UNITED STATES PATENT AND TRADEMARK OFFICE

APPLICATION NO.	FILING DATE	FIRST NAMED INVENTOR	ATTORNEY DOCKET NO.	CONFIRMATION NO.
10/789,258	02/26/2004	Jaime Bayan	NSC1P295/P05886	9477
22434	7590	09/25/2006	EXAMINER	
BEYER WEAVER & THOMAS, LLP			DOAN, THERESA T	
P.O. BOX 70250			ART UNIT	
OAKLAND, CA 94612-0250			PAPER NUMBER

Office Action Summary	Application No.	Applicant(s)	
	10/789,258	BAYAN ET AL.	
	Examiner	Art Unit	
	Theresa T. Doan	2814

DETAILED ACTION

INVERTED FIG. 2

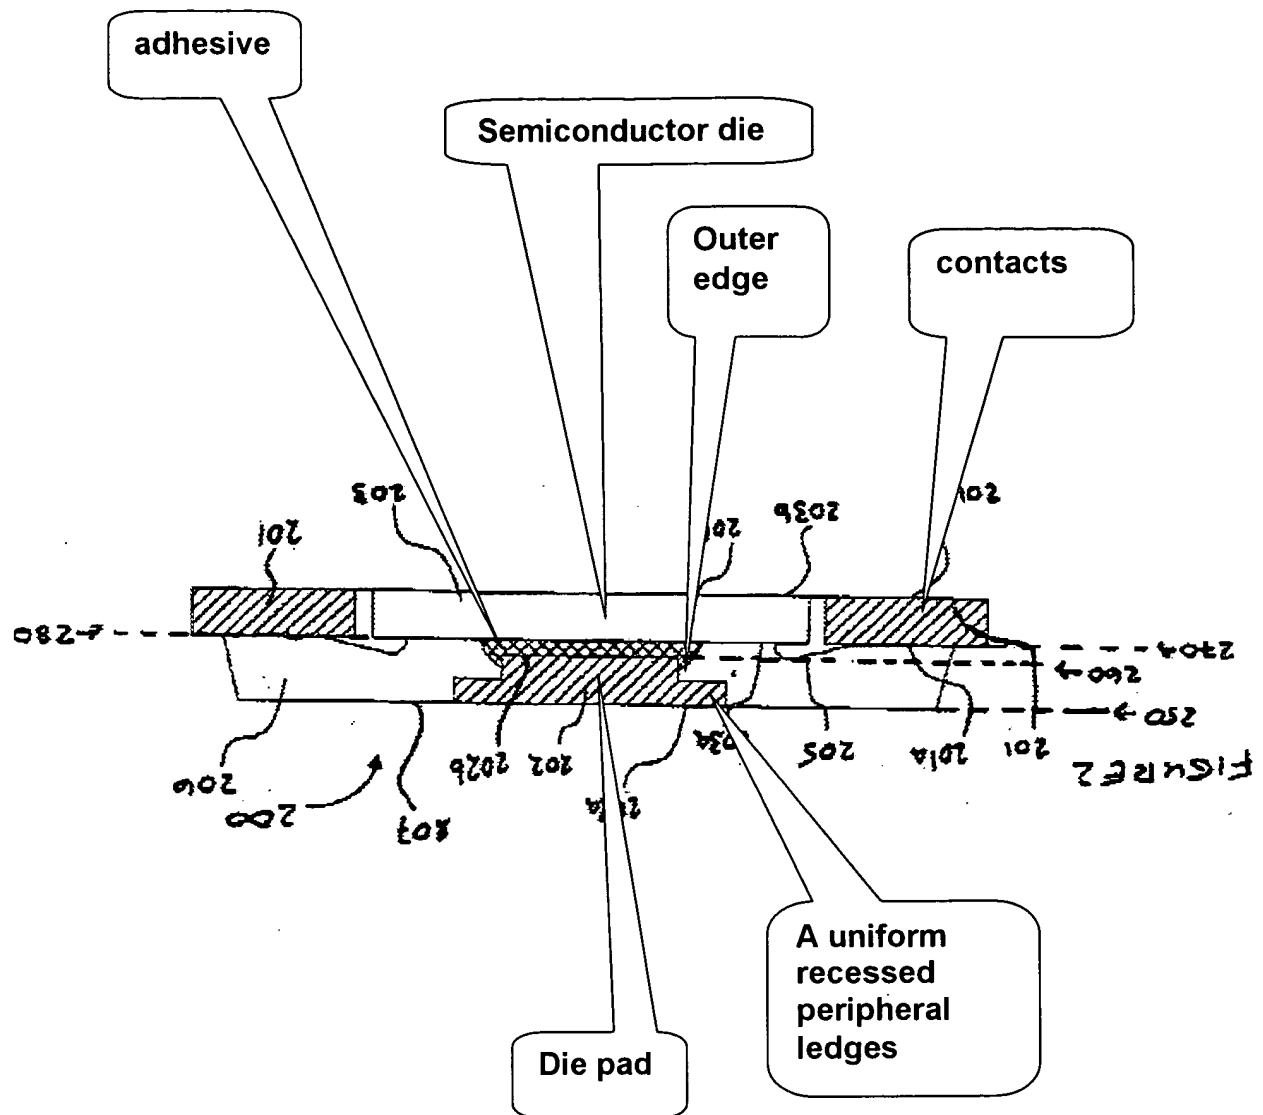
Regarding claims 2 and 9, Tan in inverted Fig. 2 discloses a substrate panel for use in semiconductor packaging, the substrate panel comprising: a lead frame panel (Figs. 8-9) including a plurality of device areas, each device area having a die attach pad 202 and a plurality of contacts 201 (in inverted Fig. 2, paragraph [0033], lines 3-8), wherein each die attach pad 202 includes a die support surface 202b and a uniform peripheral ledge that is recessed relative to the die support surface, wherein the uniformly recessed peripheral ledges extend around the outer edges of the die attach pads 202 (see inverted Fig. 2 labeled by the examiner below); and

a plurality of semiconductor dies 203 (paragraph [0034], line 1), each die 203 being attached to the die support surface 202b of an associated die attach pad 202 using an adhesive 204, wherein a portion of each semiconductor die 203 extends beyond an outer edge of its associated die attach pad 202, and wherein the ledge is configured to retain an amount of the adhesive 204 (see inverted Fig. 2 labeled by the examiner below and paragraph [0034]).

a lead frame panel (Figs. 8-9) including a plurality of device areas, each device area having a plurality of contacts 201 (in inverted Fig. 2, paragraph [0033], lines 3-8) arranged around a die attach pad 202, wherein each die attach pad 202 includes a die support surface 202b and a recessed ledge portion that is lower than the die support surface 202b and extends uniformly to an edge of the die attach pad 202 (see inverted Fig. 2 labeled by the examiner below).

Regarding claims 3 and 10, Tan discloses that each die attach pad 202 has a second surface 202a opposite to the die attach surface 202b, wherein the area of the die attach surface 202b is less than the area of the second surface 202a (See Fig. 2 labeled by the examiner above).

Regarding claims 5 and 12, Tan discloses further comprising an encapsulant 206 applied to the lead frame panel, wherein the second surfaces 202a of the die attach pads 202 and the bottom surfaces of the contacts 201 are exposed on an outer surface of the encapsulant 206, and wherein the peripheral ledges retain amounts of the adhesive 204 so as to prevent the adhesive from being exposed on the outer surface of the encapsulant 206 (See inverted Fig. 2 labeled by the examiner above).

Regarding claim 17, Tan discloses that the peripheral recessed ledge portions extend uniformly around all of the outer edge of the die attach pads 202 (See inverted Fig. 2 labeled by the examiner above).

Regarding claim 18, Tan discloses that a plurality of semiconductor dies 203 are attached to the die support surface 202b of each die attach pad 202 using an adhesive layer 204, wherein a portion of each semiconductor die 203 extends beyond an outer edge of its associated the die attach pad 202, wherein the ledge portion is configured to retain an amount of the adhesive 204 (See inverted Fig. 2 labeled by the examiner above).

Regarding claim 19, Tan discloses that each of the semiconductor dies 203 are electrically connected with the plurality of contacts 201 arranged around the die 203 and wherein each die 203 and associated electrical connections 205 to the contacts 201 are encapsulated 206 (See inverted Fig. 2 labeled by the examiner above).

However, the reference of Tan is applied in the new ground of rejection to show the invention as claimed. Specifically, in Fig. 2 of Tan discloses a die attach pad 202, wherein each die attach pad 202 includes a die support surface 202b and a uniform peripheral ledge that is recessed relative to the die support surface, wherein the uniformly recessed peripheral ledges extend around the outer edges of the die attach pads 202.

FIG. 18

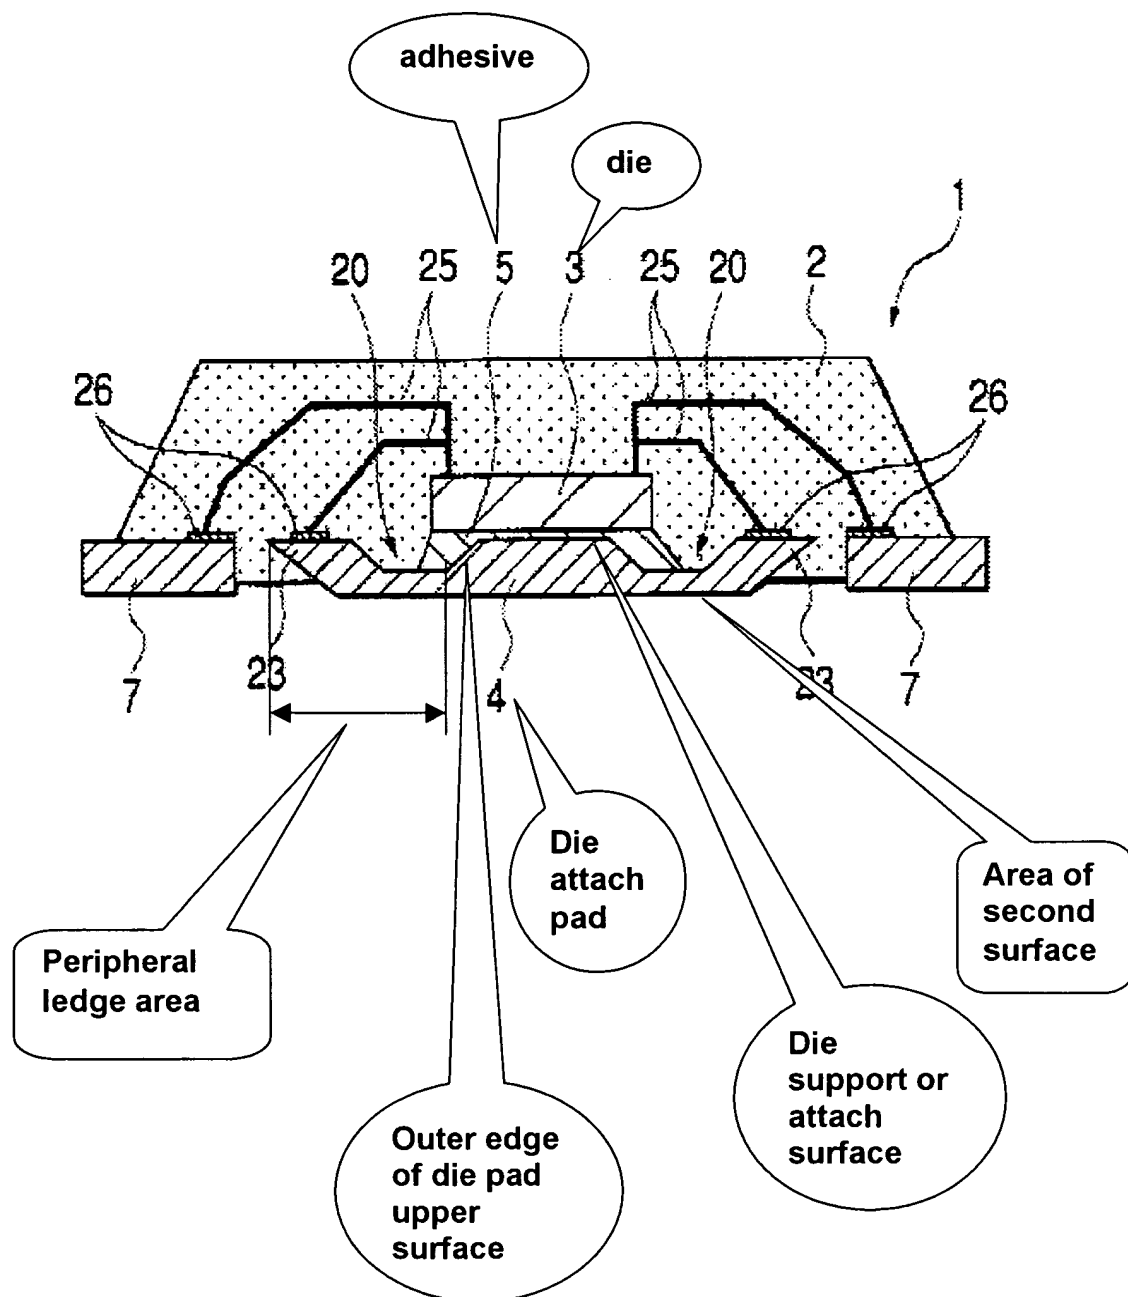
Regarding claims 2 and 9, Hasebe (Figs. 8 and 18) discloses a substrate panel for use in semiconductor packaging, the substrate panel comprising: a lead frame panel 40 including a plurality of device areas 41 (Fig. 8, column 10, lines 65-67 and column 11, line 1), each device area 41 having a die attach pad 4 and a plurality of contacts 7, wherein each die attach pad 4 includes a die support surface and a peripheral ledge that is defined as a peripheral portion which extends laterally from the bottom surface of the recess 20 to the tip portion 23 (See Fig. 18 labeled by the examiner below), the peripheral ledge is recessed relative to the die support surface, wherein the peripheral ledges extend around the outer edges of the die attach pads 4; and a plurality of semiconductor dies (see Fig. 8), each die 3 being attached to the die support surface of an associated die attach pad 4 using an adhesive 5 (Fig. 18 labeled by the examiner below), wherein a portion of each semiconductor die 3 extends beyond an outer edge of its associated die attach pad 4, and wherein the ledge is configured to retain an amount of the adhesive 5 (Fig. 18 labeled by the examiner below and column 12, lines 26-36).

Hasebe does not disclose a uniformly recessed peripheral ledges.

However, Tan (Figs. 2 and 10) discloses a die pad 1002 having a first face 1002a, a second face 1002b and a cut-out portion 1035 at the periphery of second face 1002b with a uniformly recessed surface 1002c (paragraph [0049], lines 3-16) in order to provide overflow space (paragraph [0049], lines 12-13). Accordingly, it would have been obvious to one having ordinary skill in the art at the time of the invention was made to modify the device of Hasebe by forming the uniformly recessed peripheral

Regarding claims 3 and 10, Hasebe discloses that each die attach pad 4 has a second surface opposite to the die attach surface, wherein the area of the die attach surface is less than the area of the second surface (See Fig. 18 labeled by the examiner above).

Regarding claims 6 and 13, Hasebe discloses that the semiconductors dies 3 are down bonded to the respective ledges of their associated die attach pads 4 (Fig. 18 labeled by the examiner above).

Regarding claim 17, Hasebe discloses that the peripheral ledge extend entirely around the outer edge of the die attach pads (See Fig. 18 above).

Regarding claim 18, Hasebe discloses that a plurality of semiconductor dies are attached to the die support surface of each die attach pad 4 using an adhesive layer 5, wherein a portion of each semiconductor die 3 extends beyond an outer edge of its associated the die attach pad 4, wherein the ledge is configured to retain an amount of the adhesive 5 (See Fig. 18 above and column 12, lines 26-36).
